SUBJECT : Hyundai ImageQuest Co., Ltd.
FCC ID: PJIL19A00000
Class II Permissive Change
Orig. Grant Date : March 29, 2005

Transmitted herewith, on behalf of Hyundai ImageQuest Co., Ltd. is an application for a Class II Permissive Change Certification of the following 19-inch LCD Monitor:

FCC ID : PJIL19A00000
Type No. : L19A00000

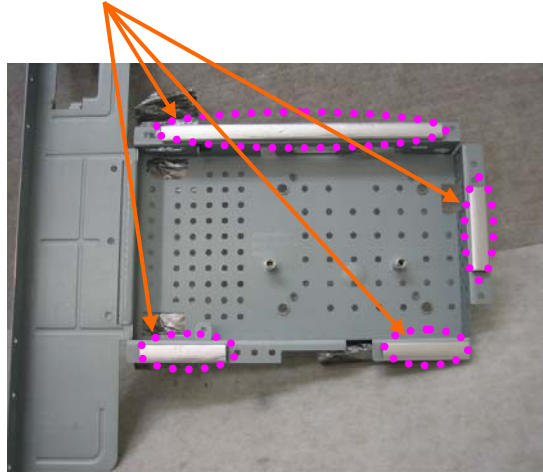
1. Attach a gasket on the main frame to contact the lcd panel

2. Attach a gasket on the main board to contact the main frame

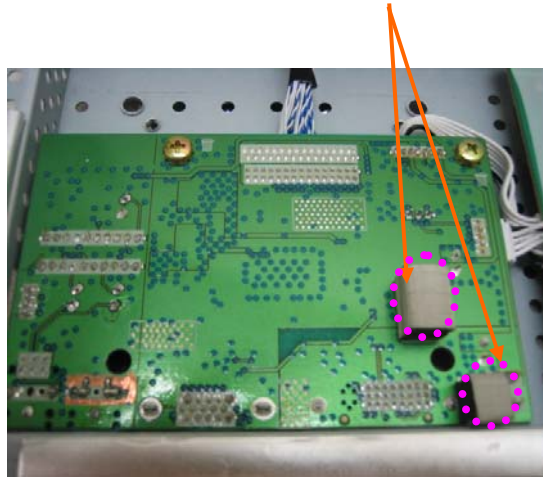
3. Attach aluminum tape on the Rear frame.
